Russell Gap Stream Mitigation Project Year 4 (2023) Monitoring Report FINAL

Alexander County, North Carolina, Catawba River Basin: 03050101-120010

Response to DMS Comments (December 15, 2023) for DRAFT Monitoring Year 4 Report.
Russell Gap Mitigation Project, Alexander County
Catawba River Basin: 06010106
DMS Project #100003 DEQ Contract #6980

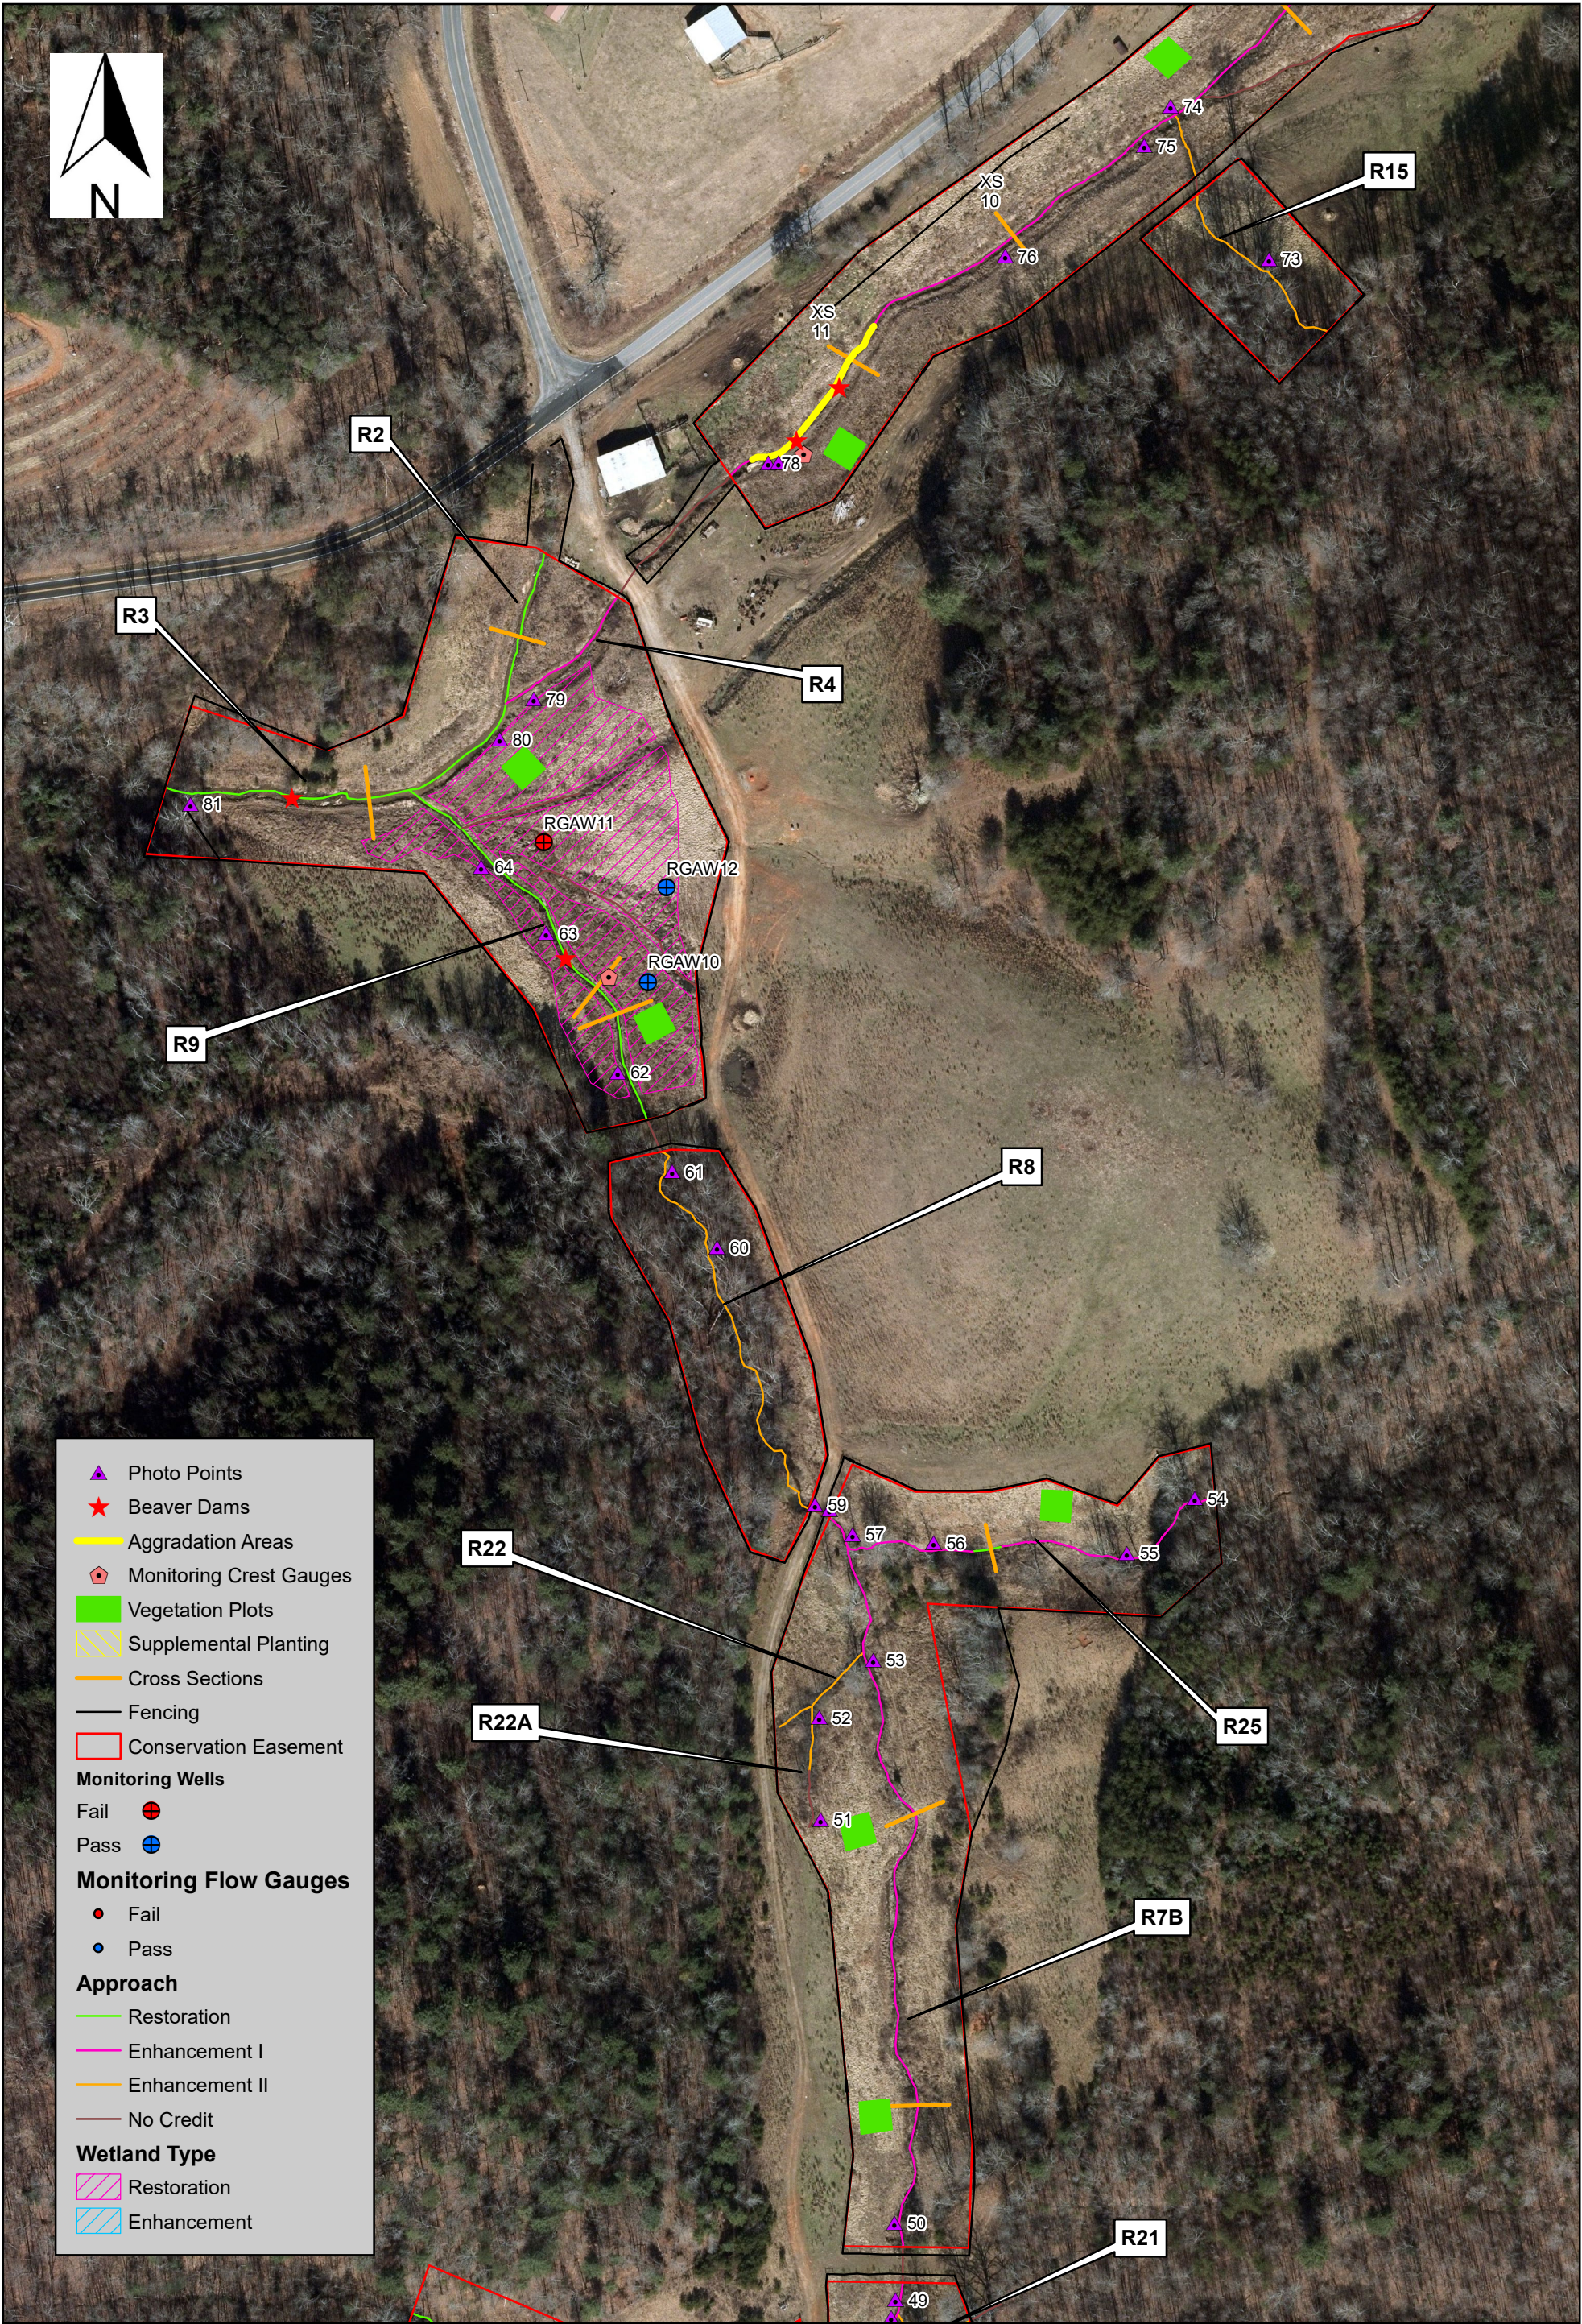
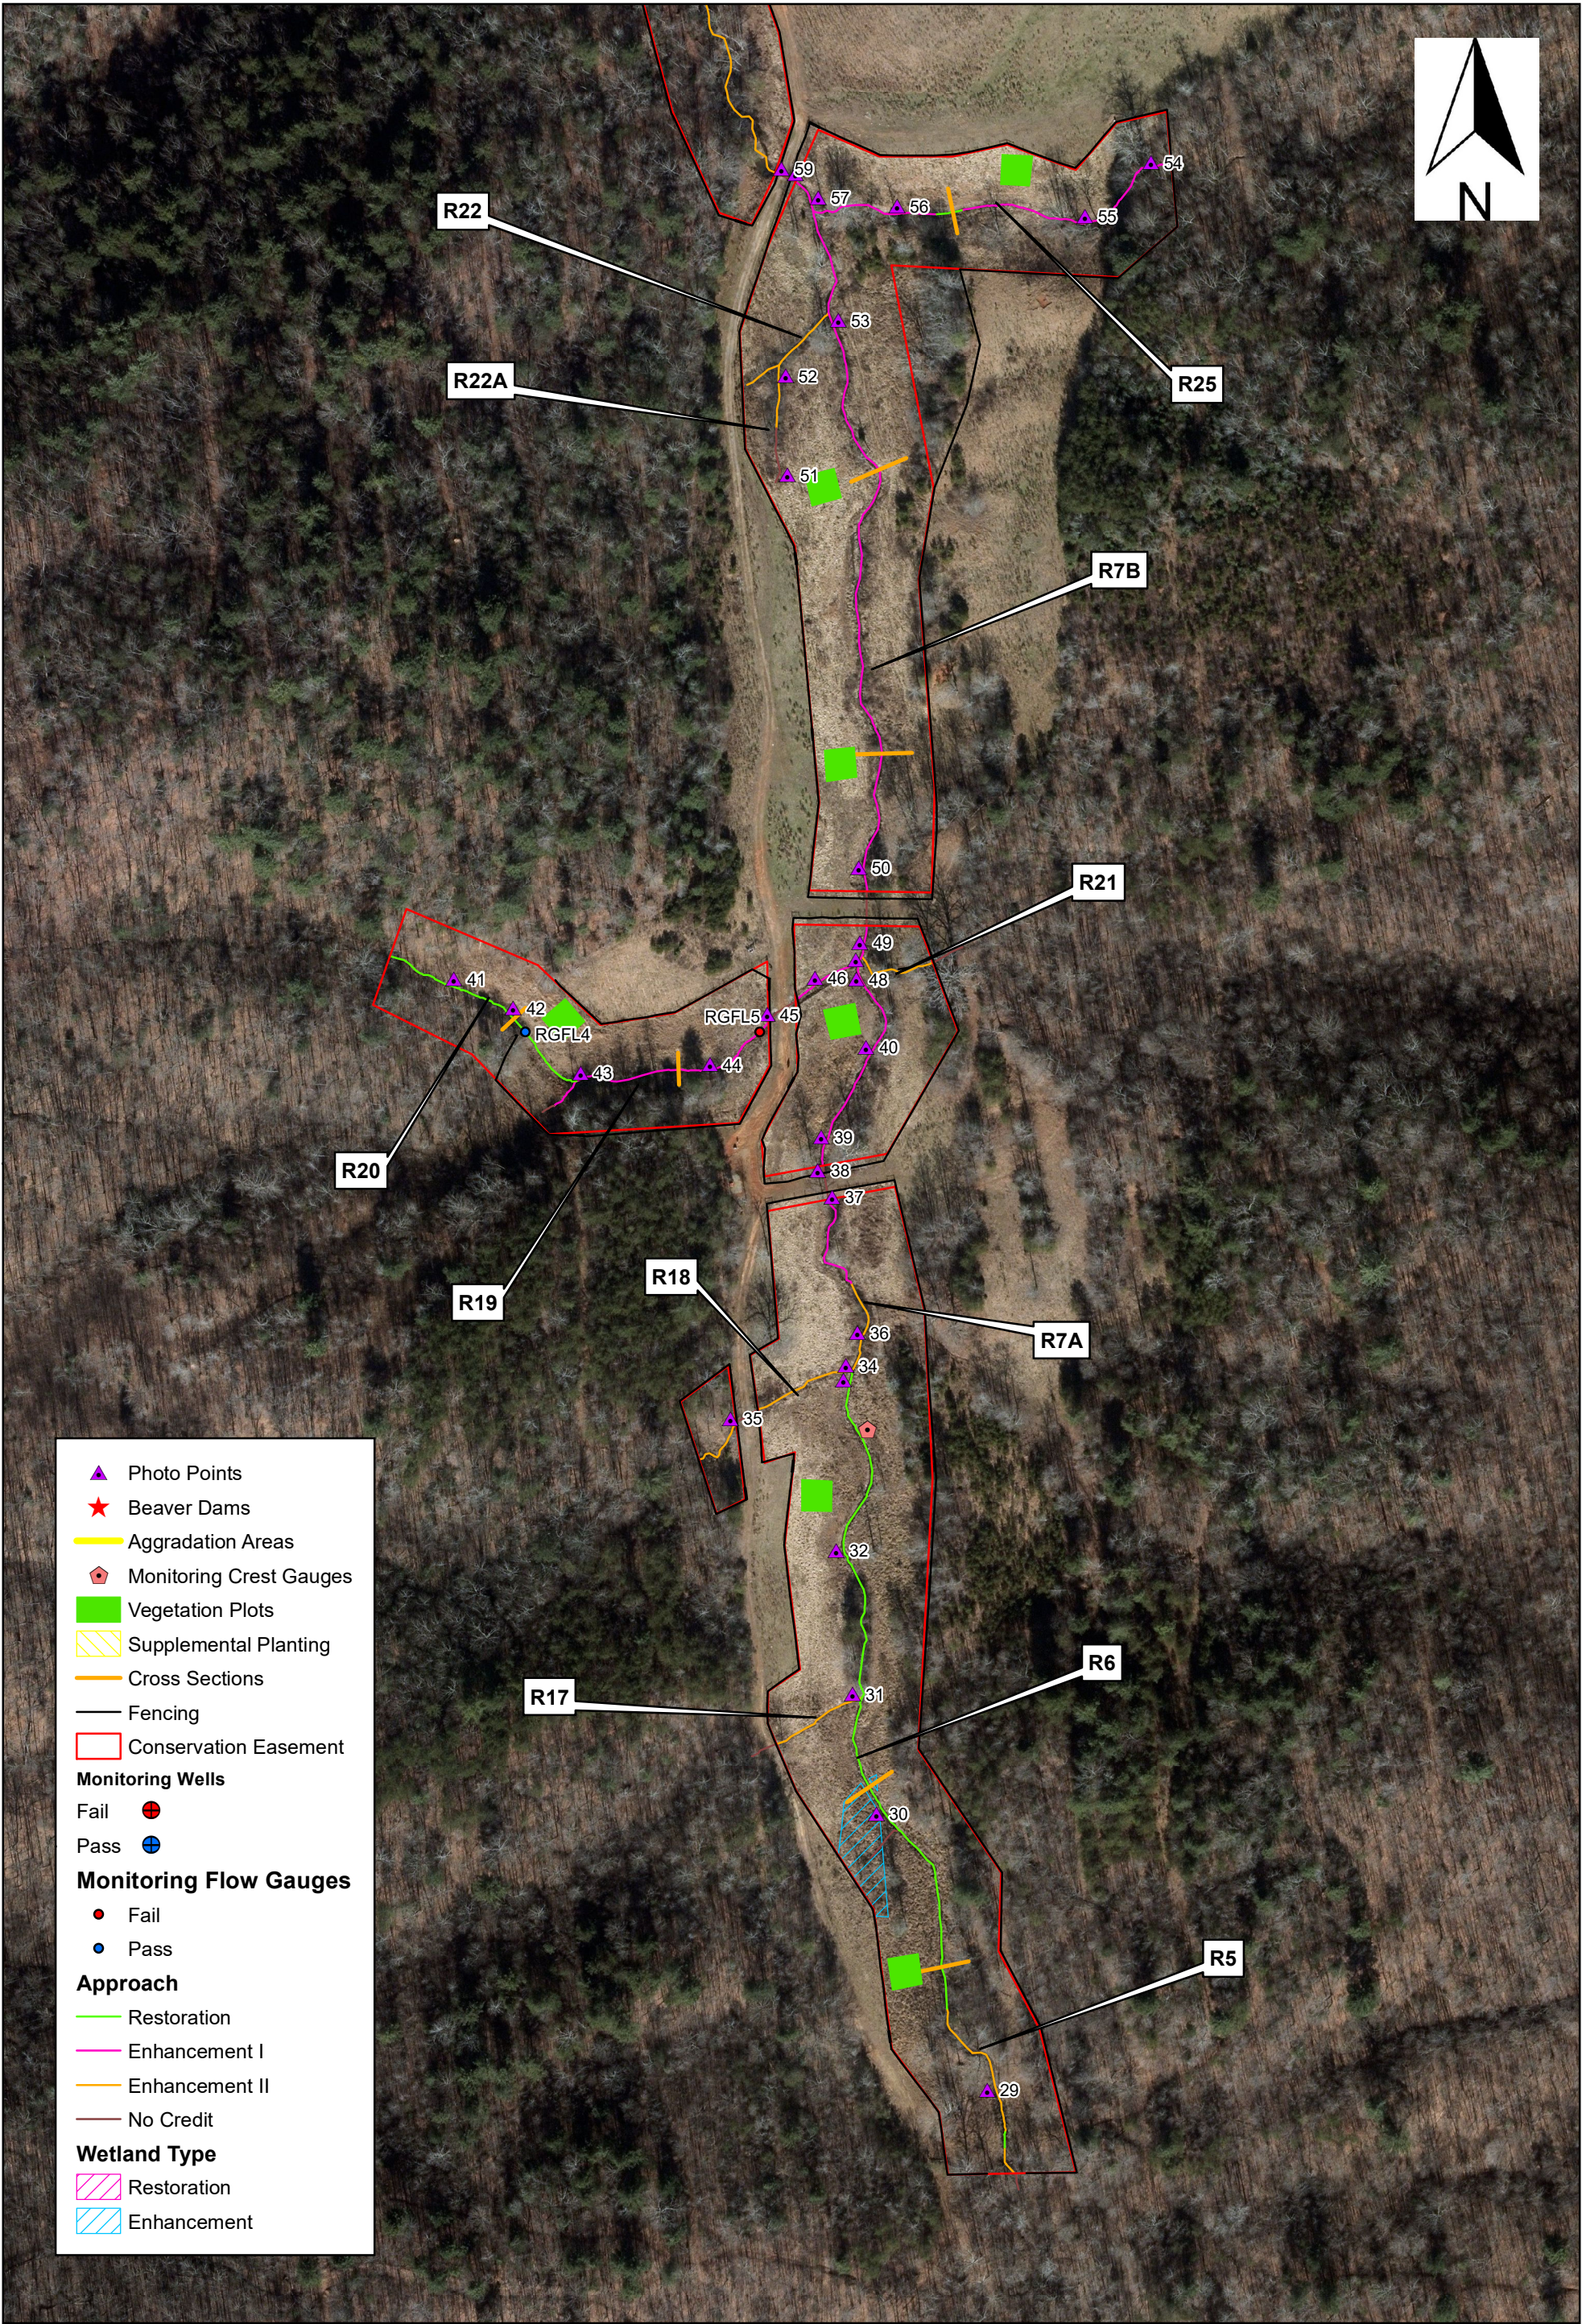
- Table 5, R1 – Table indicates 2 unstable segments totaling 220 feet. The CCPV does not show these segments. DMS assumes this aggradation is a result of the beaver dams. Please include these areas on the CCPV and include a .shp file in the revised submittal for the aggrading length.

- Table 5, R3, R4 and R9 – Same comment as above.
RESPONSE: See response above.
- Hydrology Gauge Graphs – DMS recommends downloading gauge data after the end of the growing season so the data set includes the entire growing season.

RESPONSE: These stream lengths are associated with the beaver dams and a line showing the approximate hydrologic impact has been added to the CCPVs. A shapefile has been added to the electronic submission files as requested.

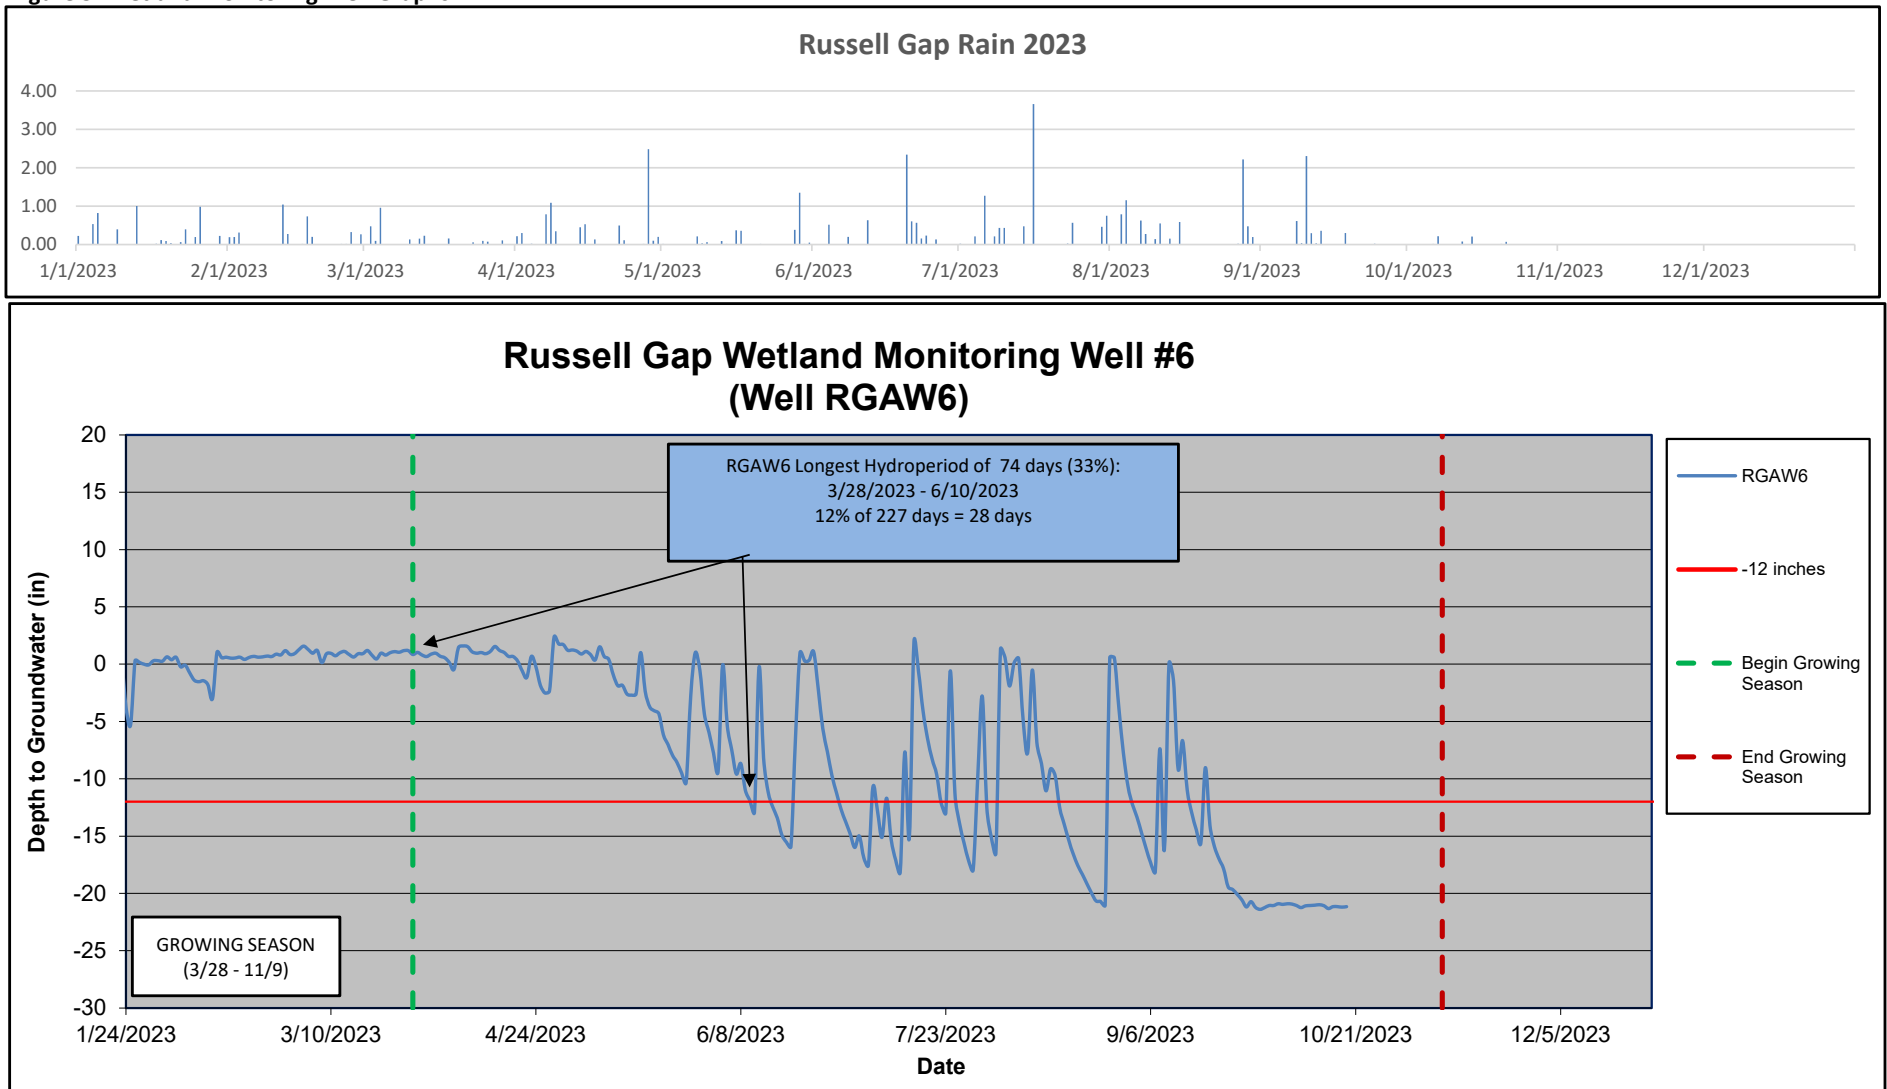
- RGAW5 Graph – Is this well functioning correctly? When compared to the other gauge graphs, the 20” drop that occurred around May 23 may indicate gauge failure. Please ensure all gauges are functioning correctly as the project moves into MY5.

RESPONSE: We agree that the data for RGAW5 appears unusual and we will ensure that the gauges are functioning correctly moving into MY5.
- The abundance of juncus found along R1 has been a concern at the site. Have the planted trees been able to out compete the juncus?
